ADDENDUM NO. 1

REYNOLDSBURG CITY SCHOOLS
L.F.O. ATHLETIC & ECO LAB PROJECTS

Date: **March 25, 2011**

Addendum No. 1 to the Drawings and Project Manual, dated **March 17, 2011**, for **L.F.O. ATHLETIC & ECO LAB PROJECTS**, Reynoldsburg City Schools, 7244 East Main Street, Reynoldsburg, Ohio 43068; as prepared by Moody Nolan, Inc., 300 Spruce St. Suite 300, Columbus, OH 43215.

A-SK01

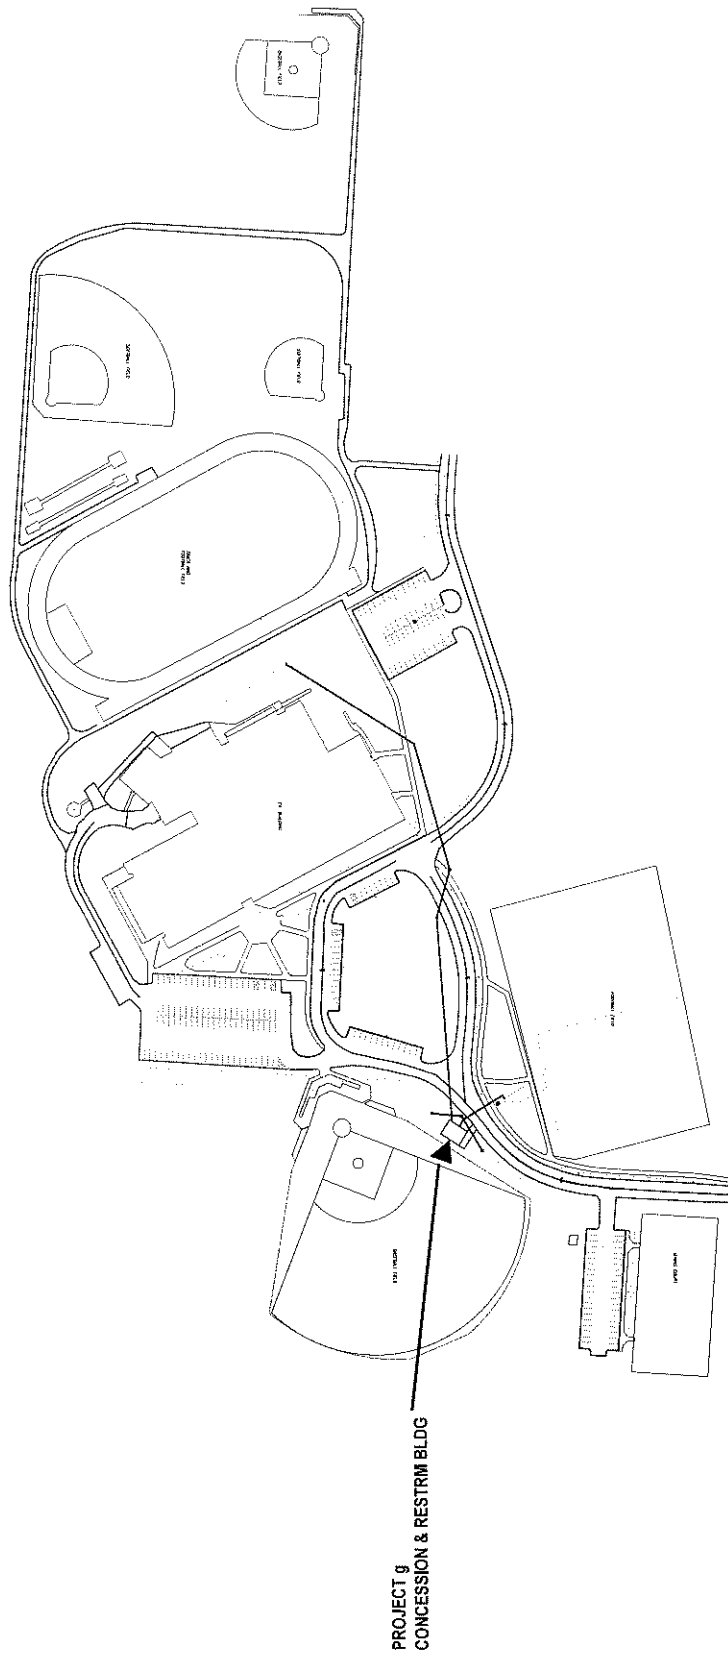
- Item 1-5 Vol. 1, SHEET X1.2
A. **ADD:** BALDWIN ROAD SITE PLAN, see A-SK01.
- Item 1-6 Vol. 1, SHEET Xa1X
A. **REVISE in Sub Index of Drawings – Volume 1:** Sheet titles Xa1X, T0.01 and T0.02 to match the sheet titles in each corresponding border. Sheets Pa1.11 and Pa1.11F sheet order exchanged.

A-SK02

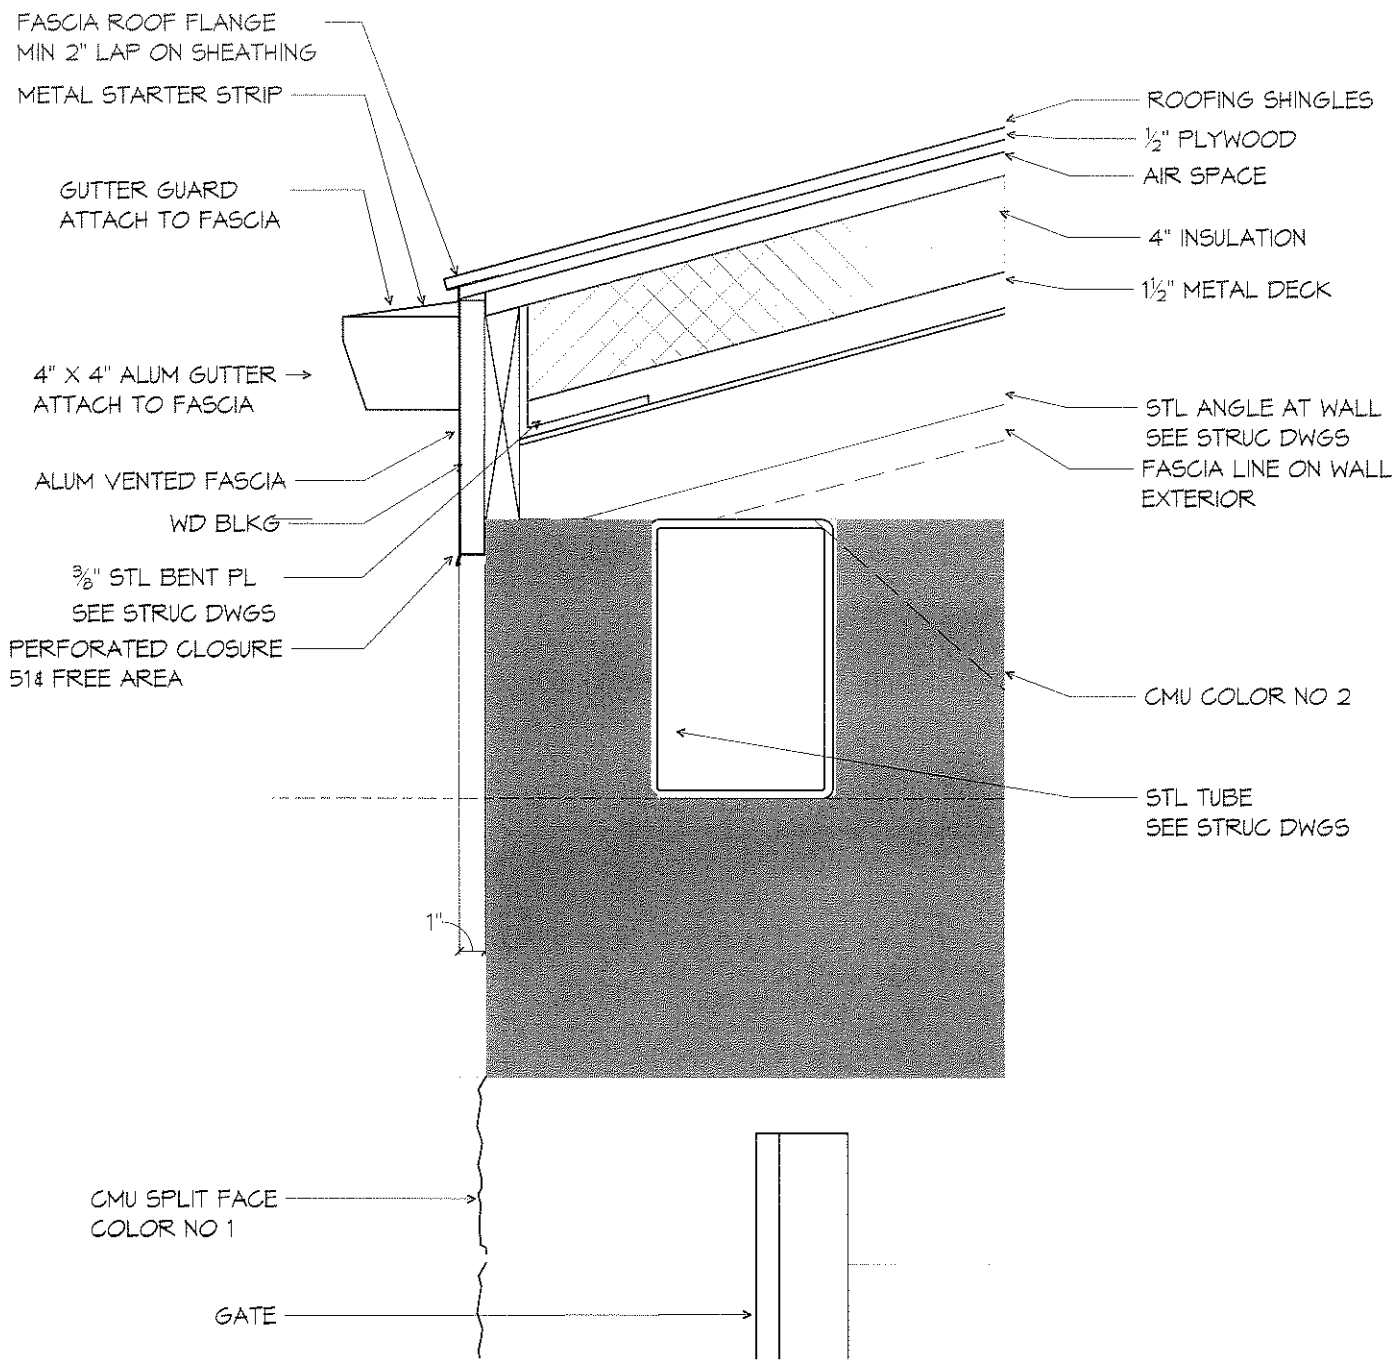
A. **REPLACE:** Door & Frame Schedule attached, see A-SK02.
- Item 1-19 Vol. 1, SHEET Aa8.1
A. **REVISE:** Section 12, change dashed line to solid line for safe. The safe is to be provided under Section 10 80 00.

ISSUED WITH ADDENDUM 1	SHEET REVISED Aa7.1
SKETCH NUMBER A-SK05	
PROJ # 00177.1	DRAWN BY JKS
DATE 3/25/11

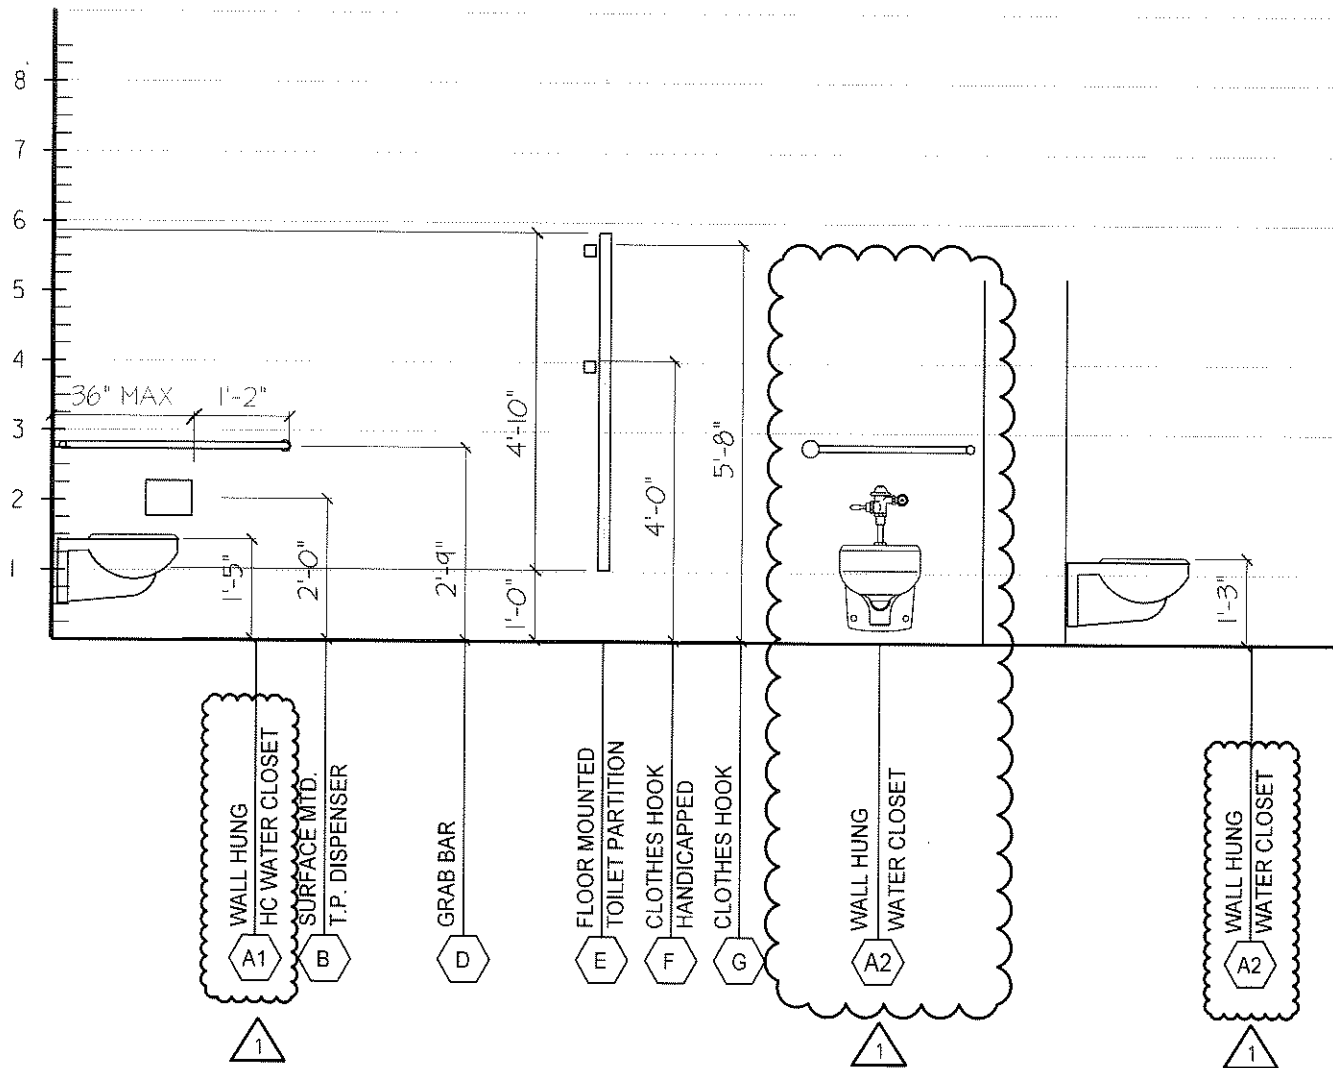
- Item 1-20 Vol. 1, SHEET Aa8.1
A. **REVISE:** Section 5, missing information provided, see A-SK04.
- Item 1-21 Vol. 1, SHEET Aa8.2
A. **REVISE:** Fixture mounting height schedule modified, see A-SK05.

ISSUED WITH ADDENDUM 1	SHEET REVISED Aa7.1
SKETCH NUMBER A-SK06	
PROJ # 00177.1	DRAWN BY JKS
DATE 3/25/11

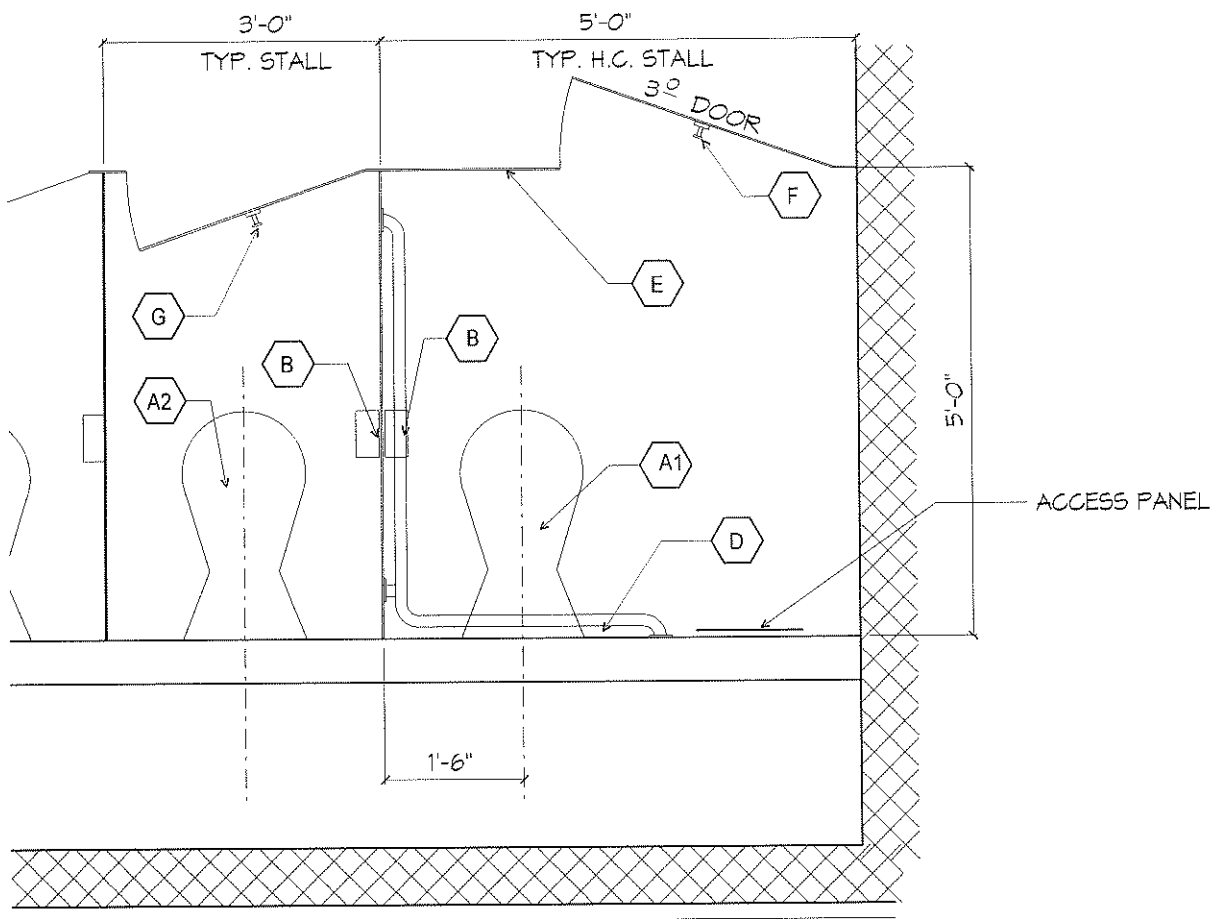
- Item 1-22 Vol. 1, SHEET Aa8.2
A. **REVISE:** Fixture mounting height schedule modified, see A-SK06.
- Item 1-23 Vol. 1, SHEET Aa8.3
A. **DELETE:** Bollard detail 5/Aa8.3.
